STANDARD AMDOR MOUNTING PLATE INSTALLATION LOCATION CHANGE

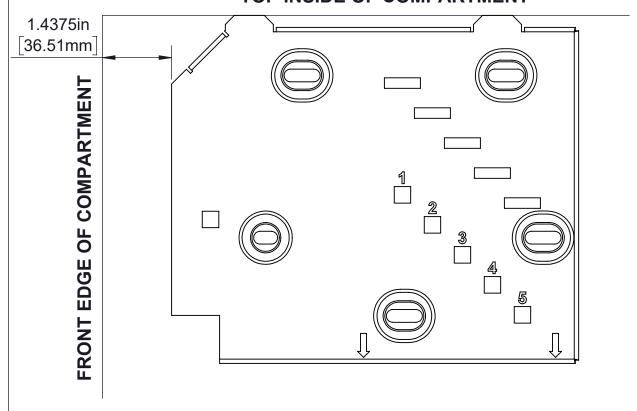
AMDOR Mounting Plate installation position from the front edge of the compartment has been changed to 1-7/16" [previously 1-5/16"]. Only the Left-Hand plate is shown here. The Right-Hand plate should be positioned at the same distance.
